MISSISSIPPI RIVER - GULF OUTLET  
LOUISIANA

-----  
DESIGN MEMORANDUM NO. 1-A

CHANNELS

SUBJECT: Design Memorandum No. 1-A, CHANNELS Mississippi River - Gulf Outlet (NOD ltr 30 Apr 57)

DESIGN MEMORANDUM NO. 1—A  
CHANNELS  
MILE 63.77 TO MILE 68.85  
PROJECT LOCATION

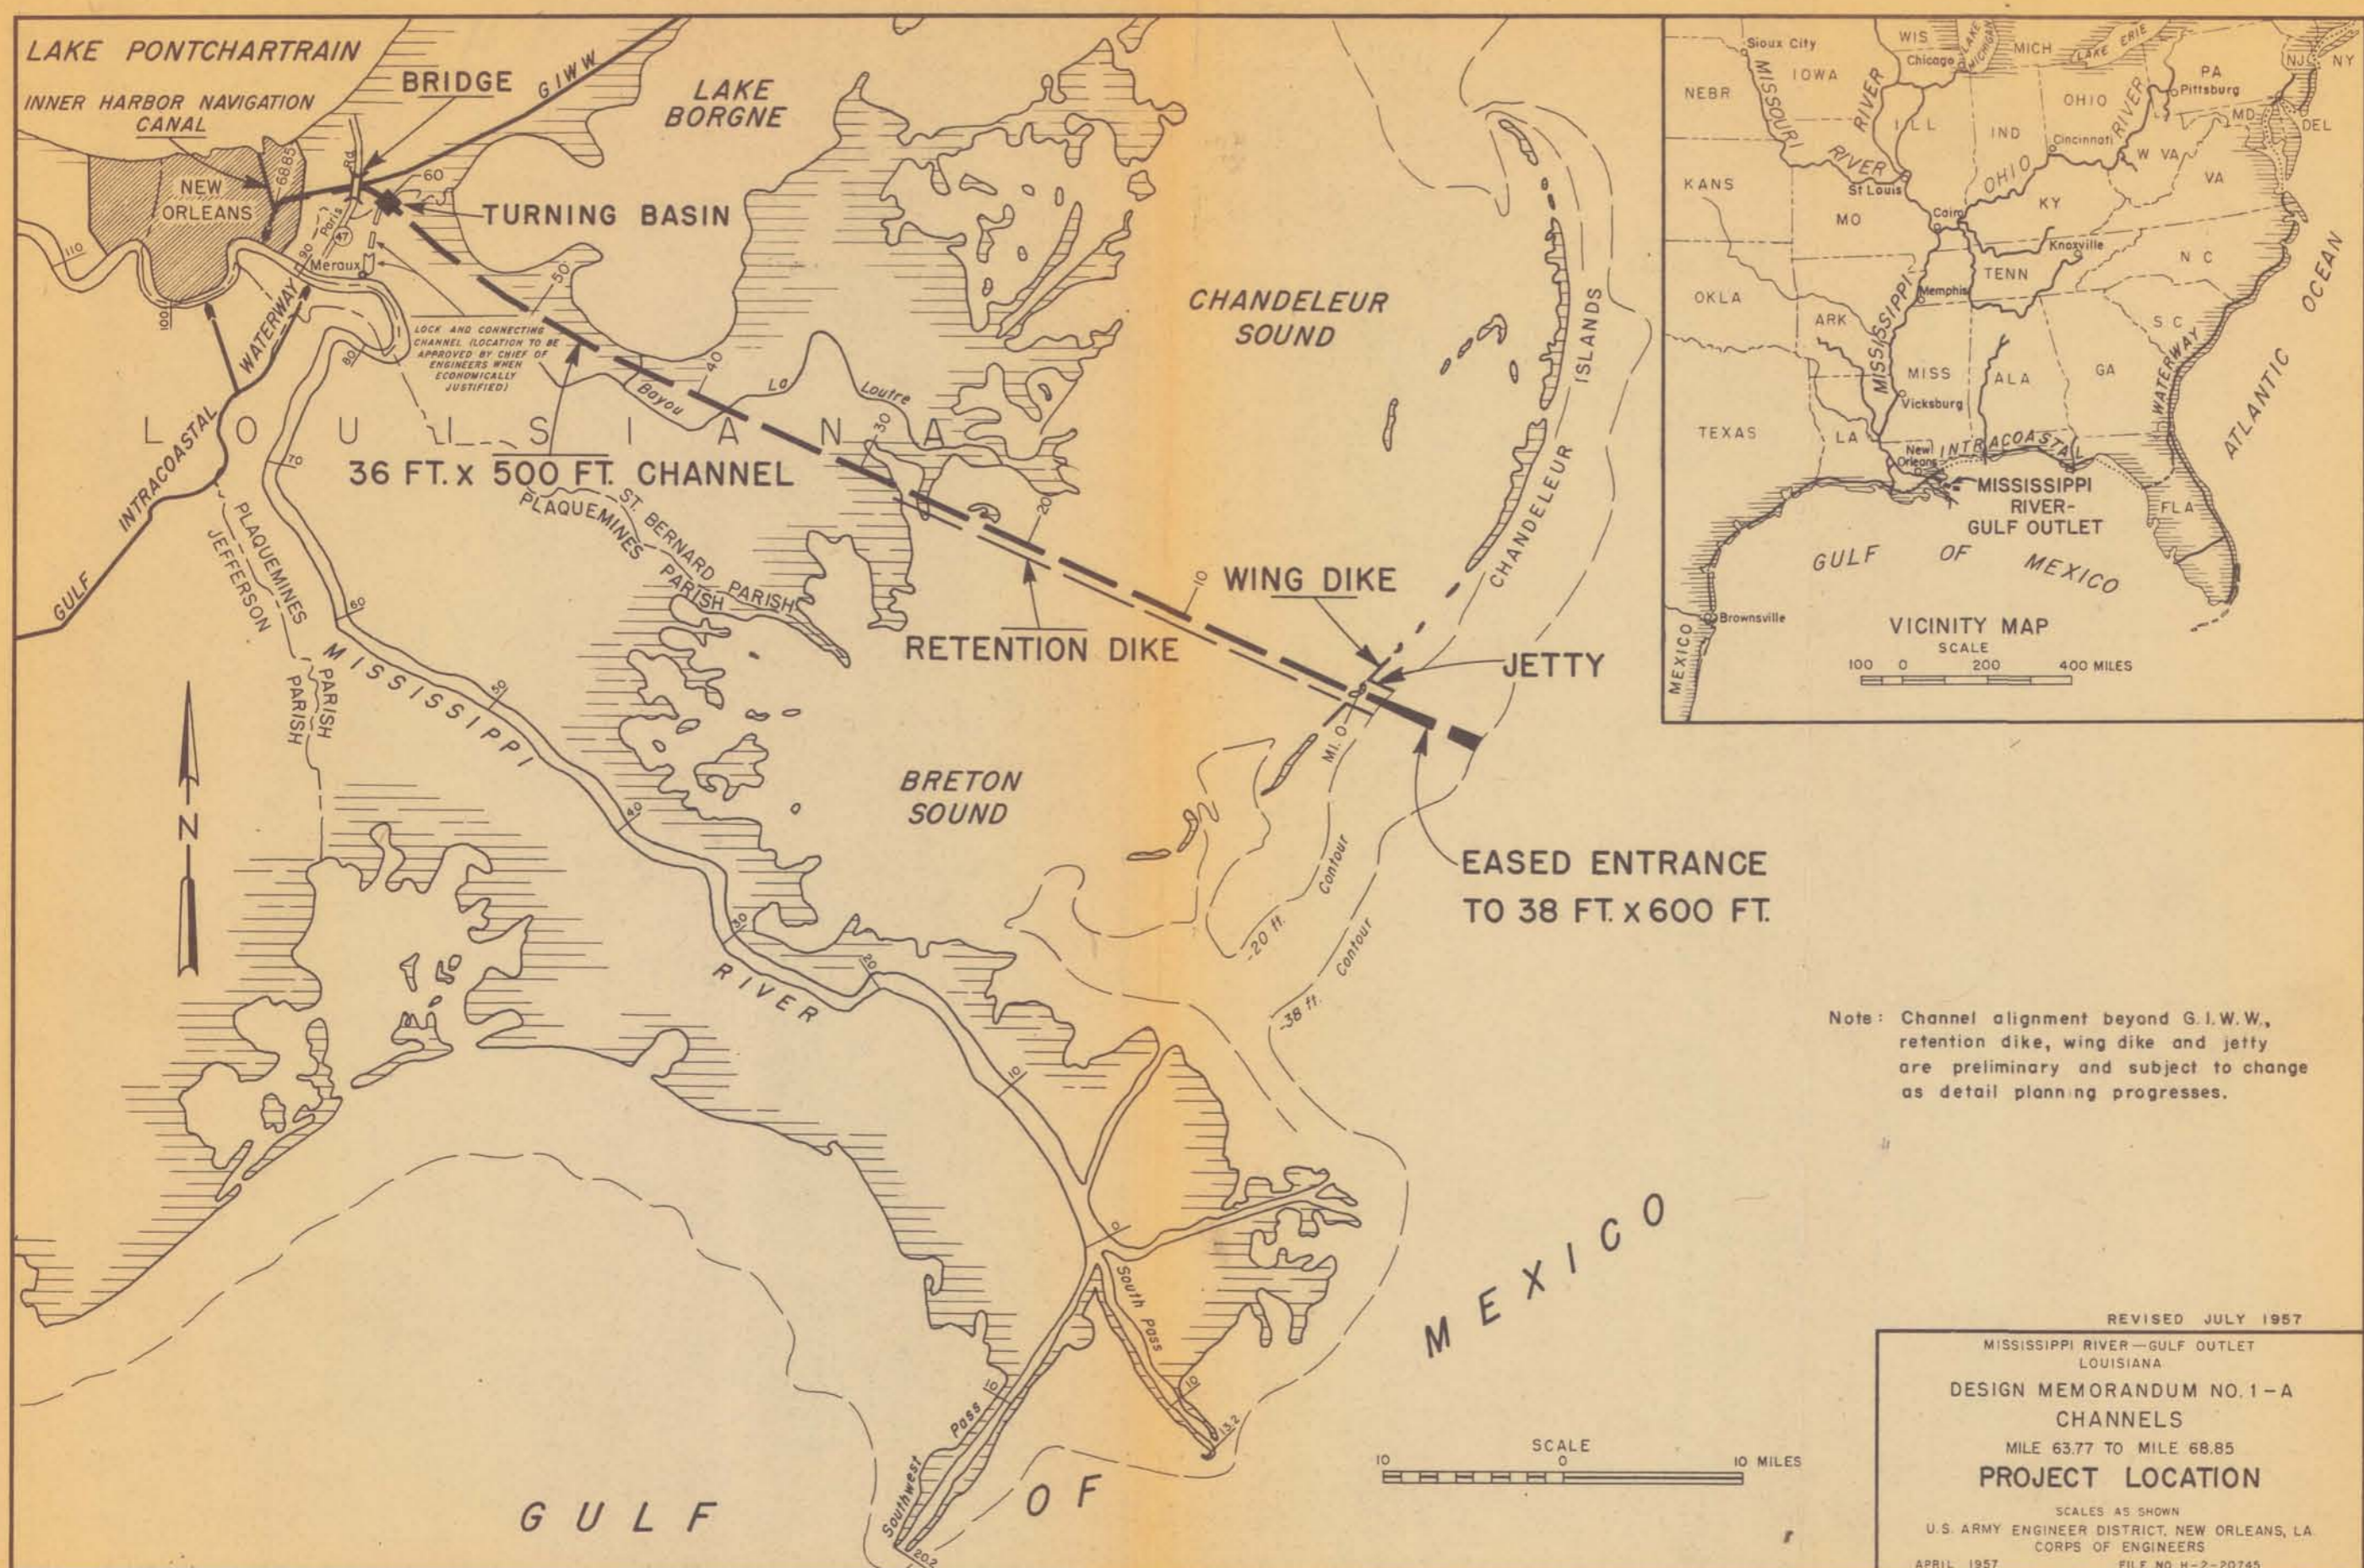
- e. Plate 1. Inasmuch as the alignment beyond the G.I.W.W. is still under study, a notation should be made on this plate that the alignment, retention dike, wing dike, and jetty are preliminary.

Note: Channel alignment beyond G.I.W.W., retention dike, wing dike and jetty are preliminary and subject to change as detail planning progresses.

MISSISSIPPI RIVER - GULF OUTLET  
 LOUISIANA  
**DESIGN MEMORANDUM NO. 1-A**  
**CHANNELS**  
 MILE 63.77 TO MILE 68.85  
**PLAN, PROFILE AND SOIL BORINGS**

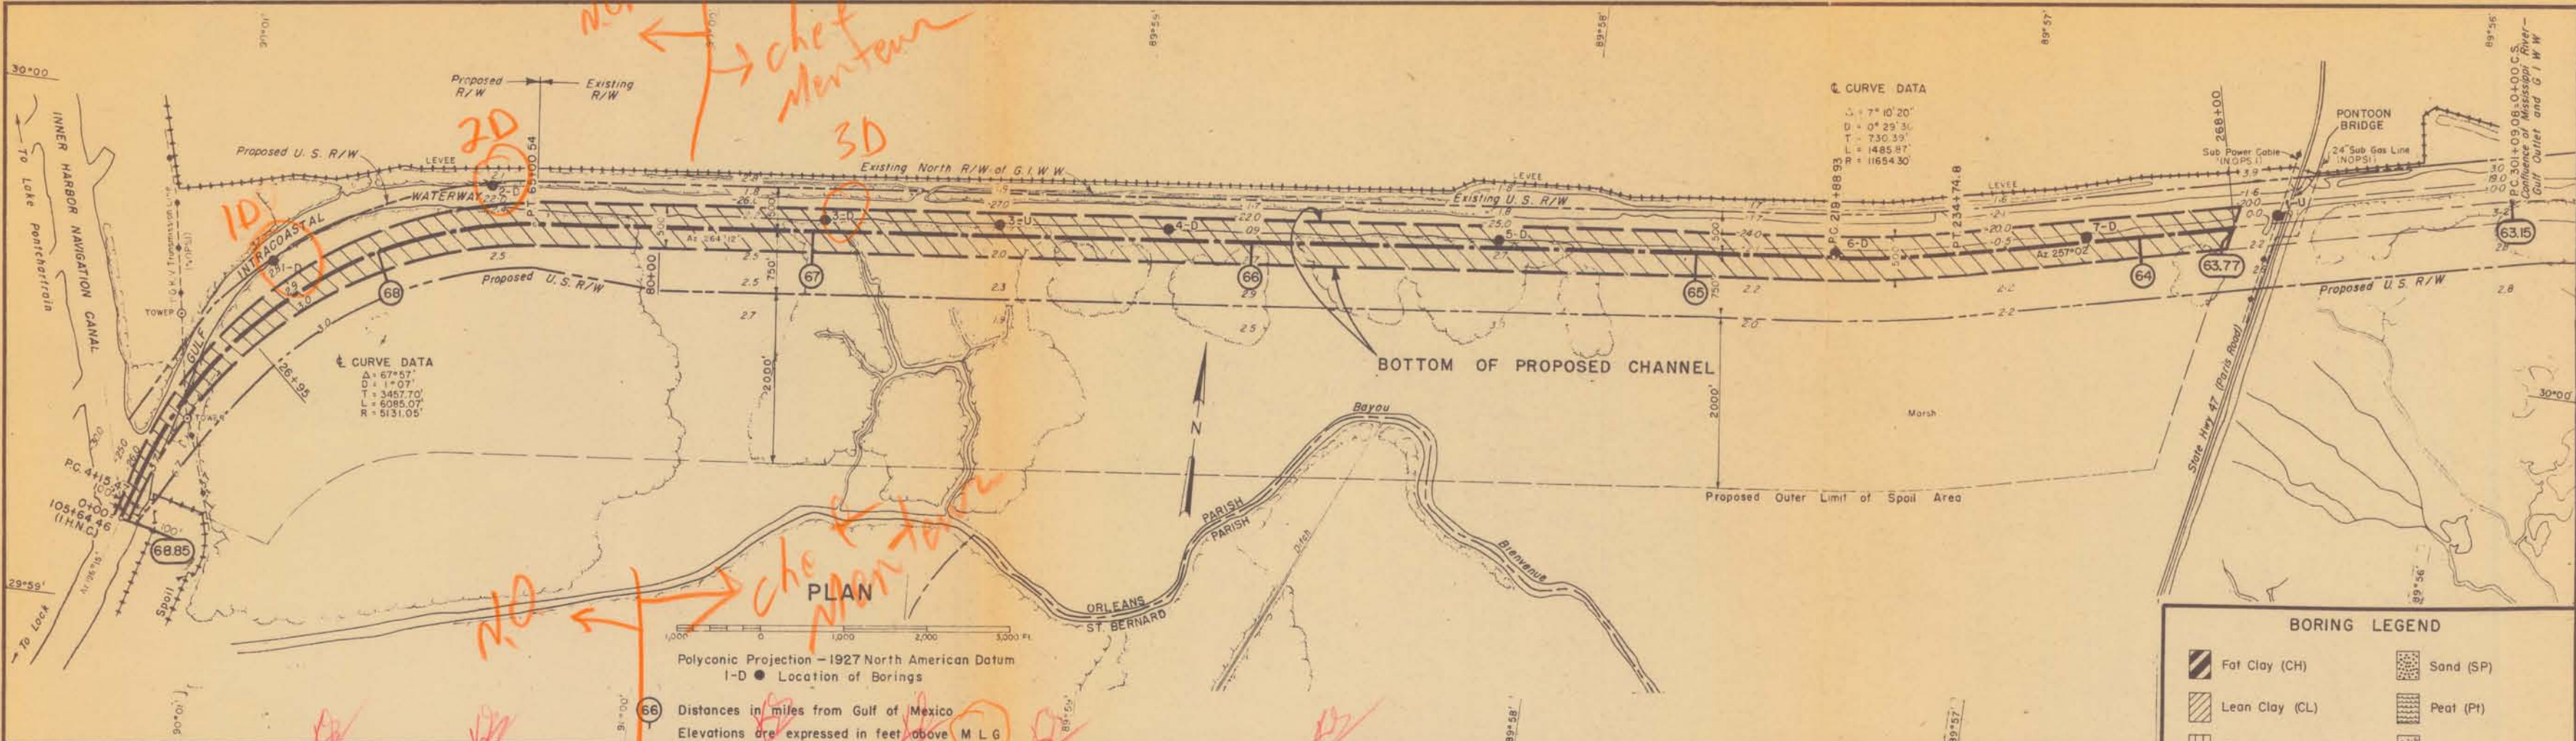
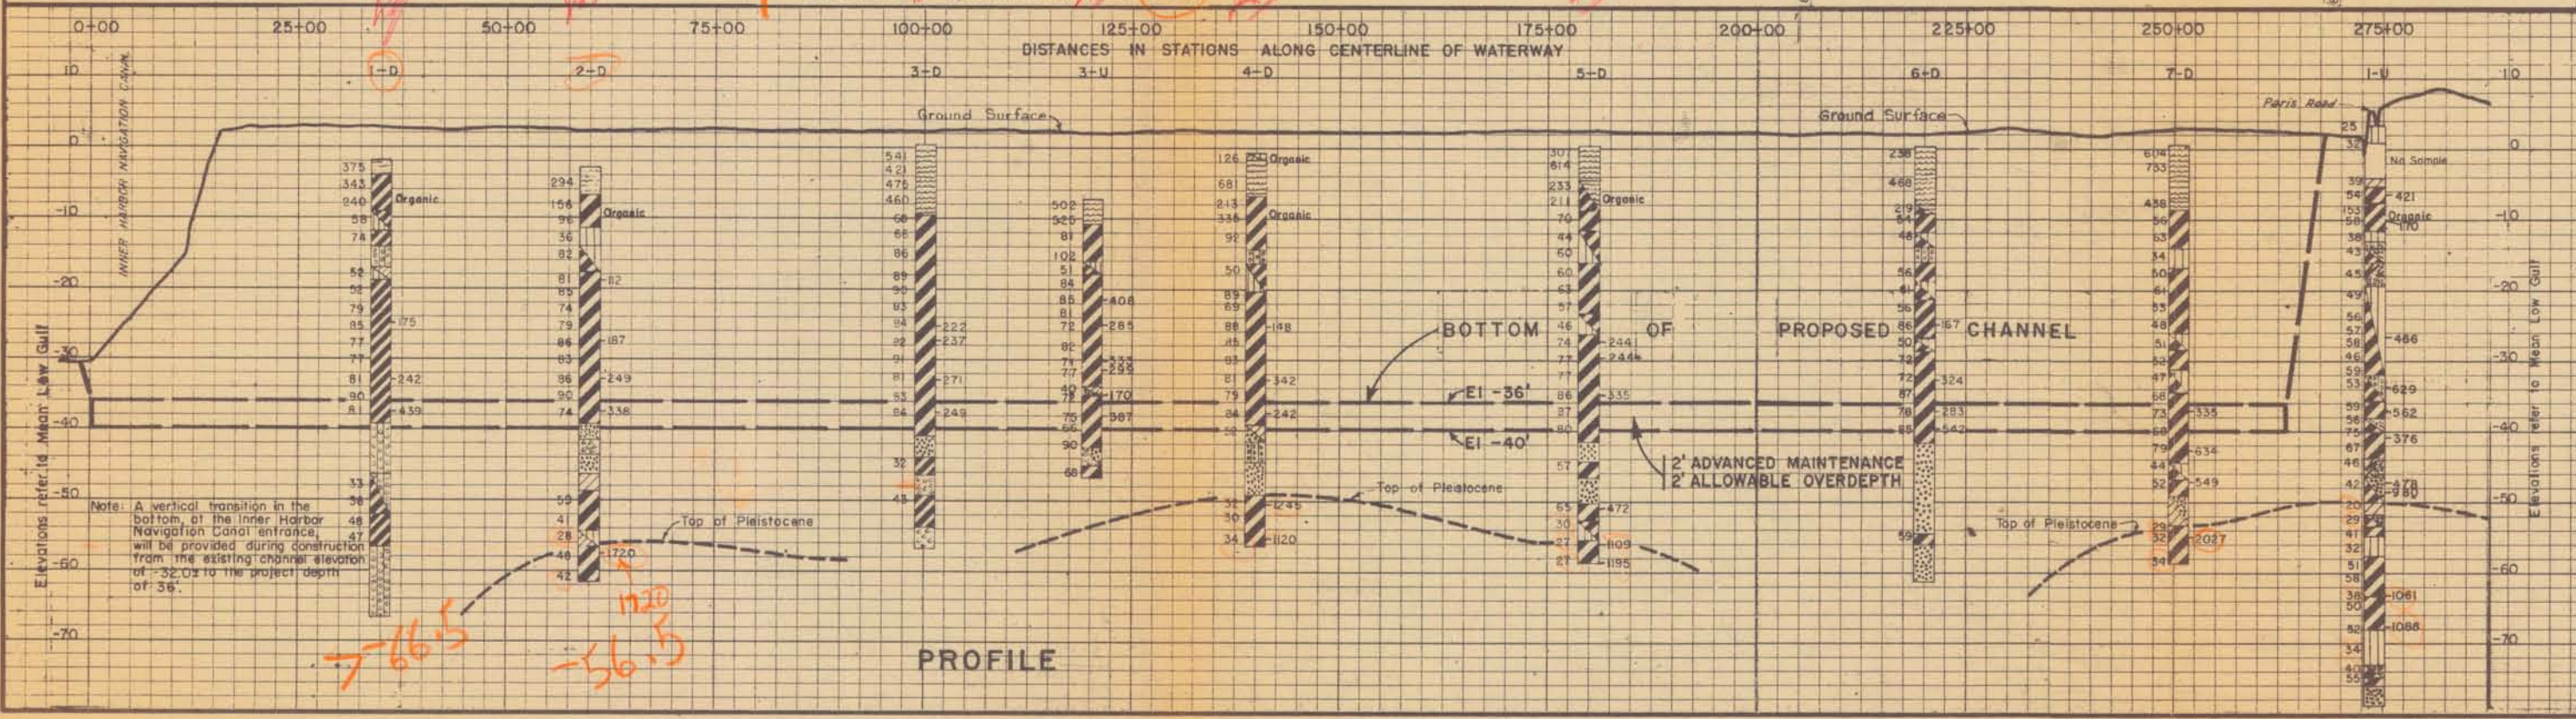
- f. Plate 2. The shear strengths obtained for samples taken from borings 3-U and 1-U should be shown adjacent to the boring logs.
- g. Plate 4. The cohesive strength of the stratum of peat is shown as 250 pounds per square foot in Case 1 and 150 in Case 2. This discrepancy should be corrected.

**TYPICAL SECTIONS**

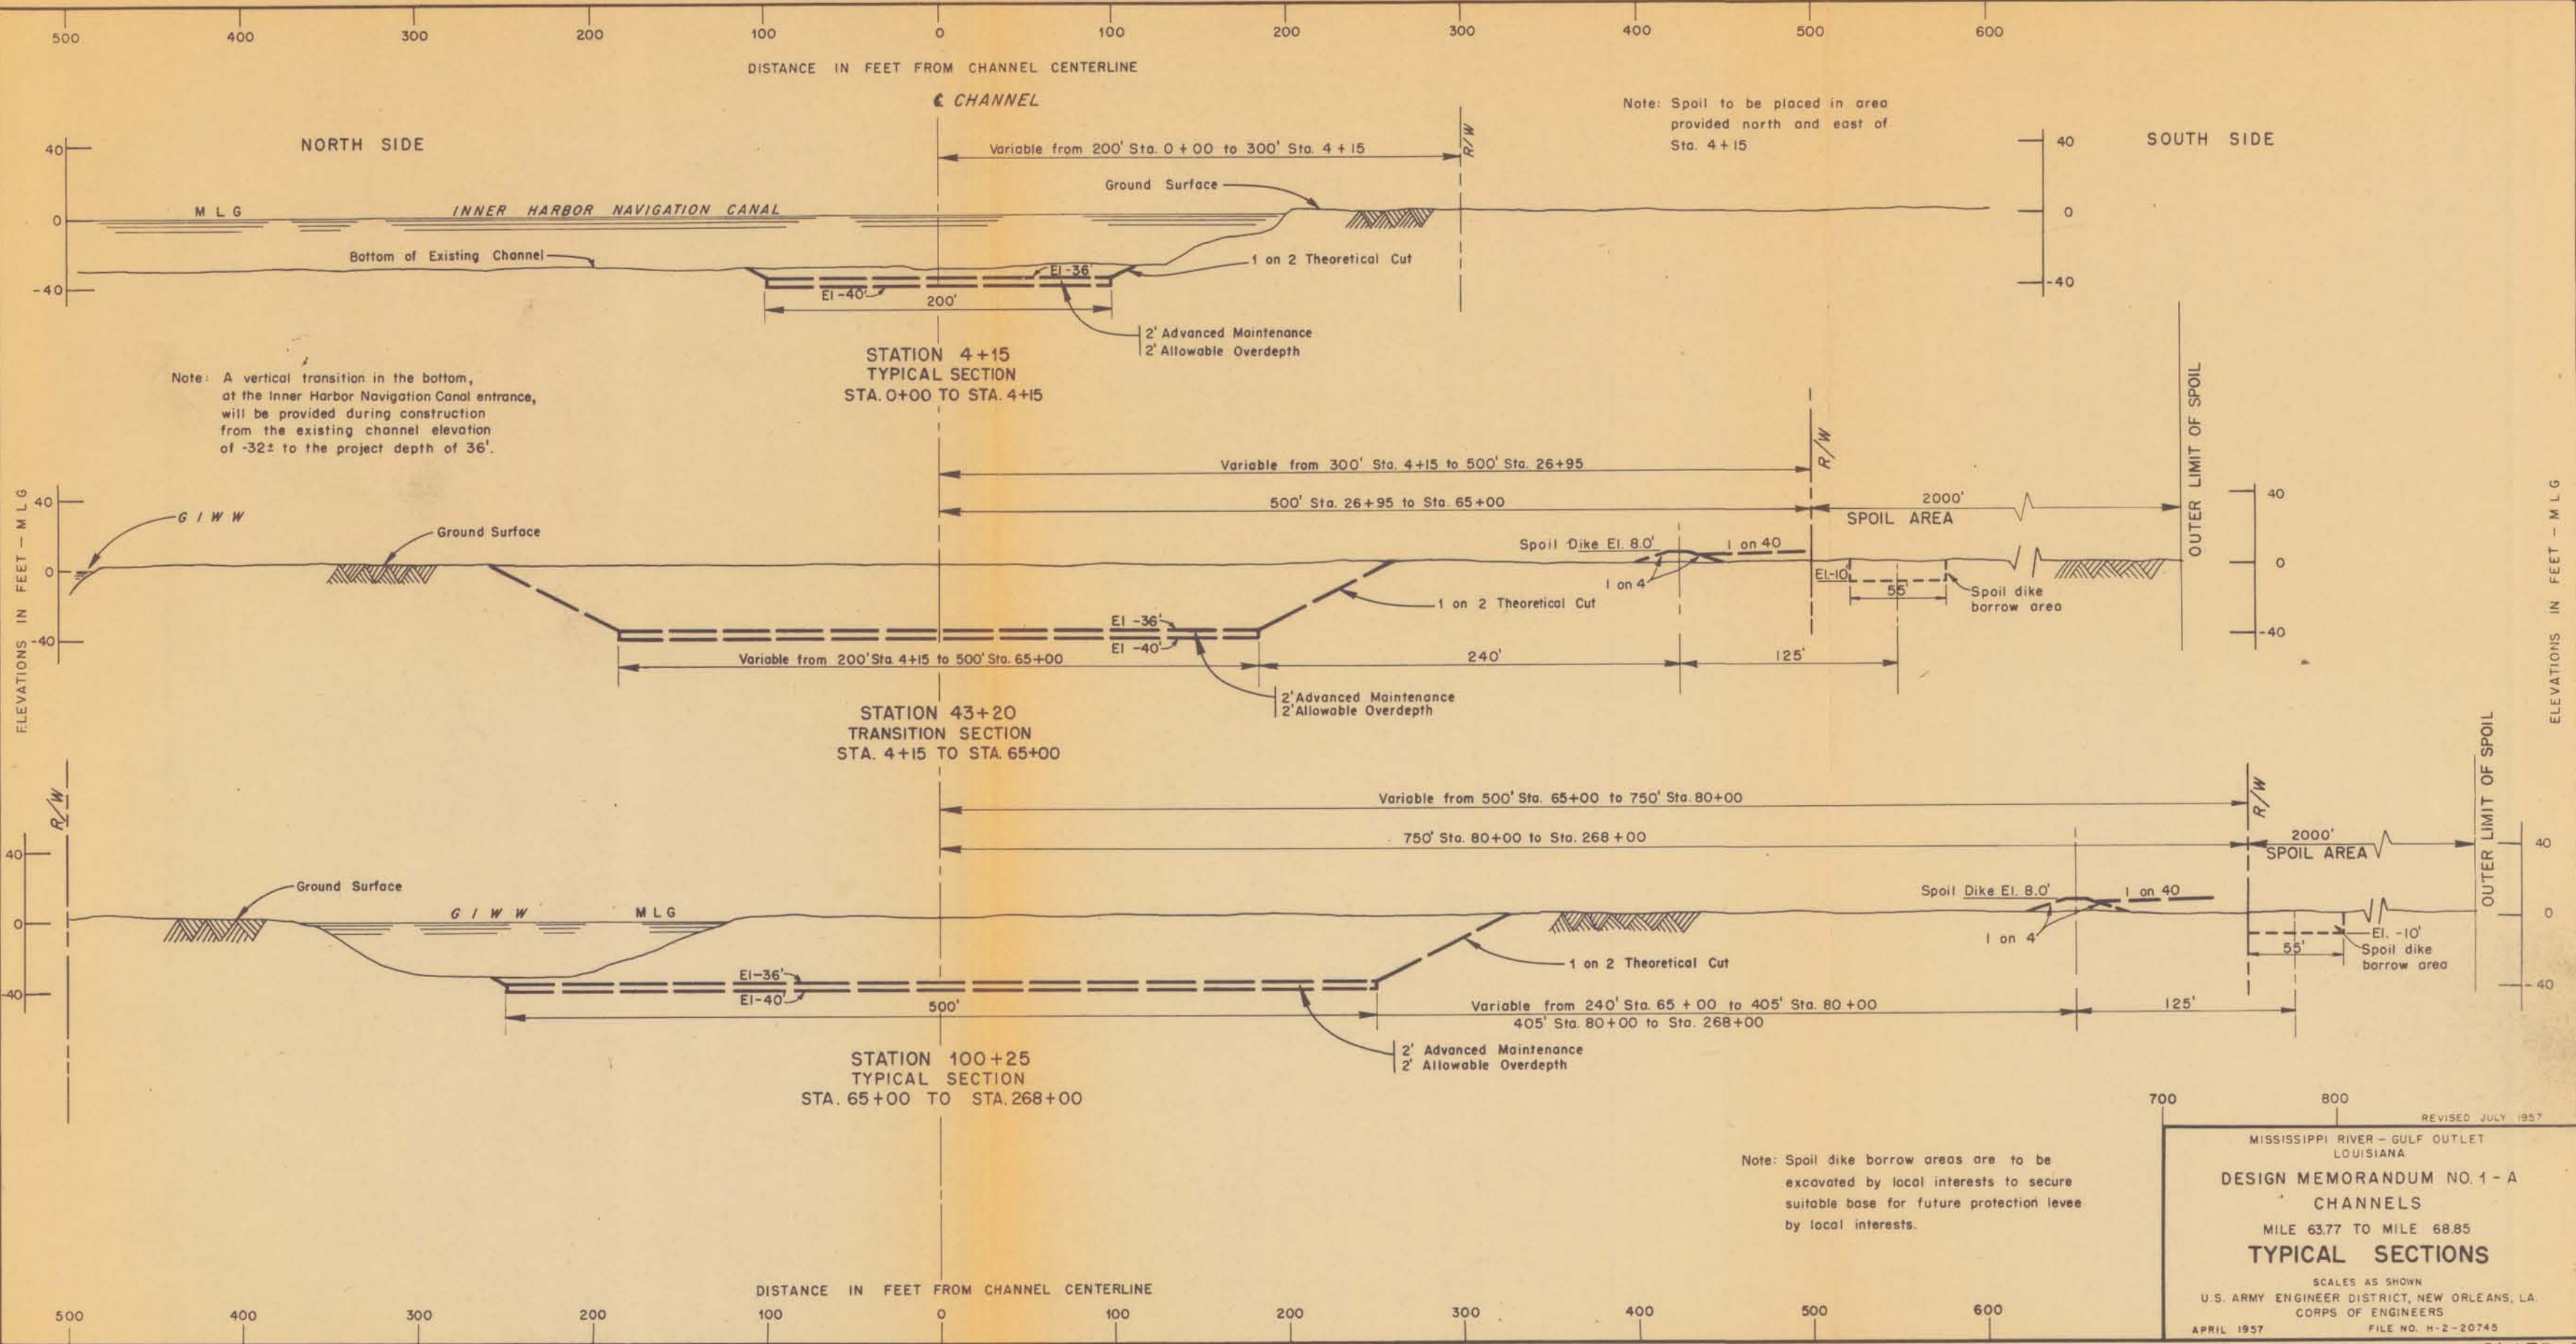
1. Subject design memorandum has been revised in accordance with comments of 1st Indorsement.
2. A statement has been added to paragraph 13 in addition to changes made in paragraph 15 in response to the comment appearing in paragraph "b" of the 1st Indorsement.
3. Typical sections on Plate 5 have been revised to show spoil dike borrow areas being excavated by "local interests." Recently "local interests" have proposed that they be permitted to excavate the undesirable material from under the location of a proposed protection levee and to place this material in the form of a spoil retention dike to be made available for use by the Government. The spoil from the channel excavation will be graded and shaped into a levee by local interests.
4. Approval is recommended.
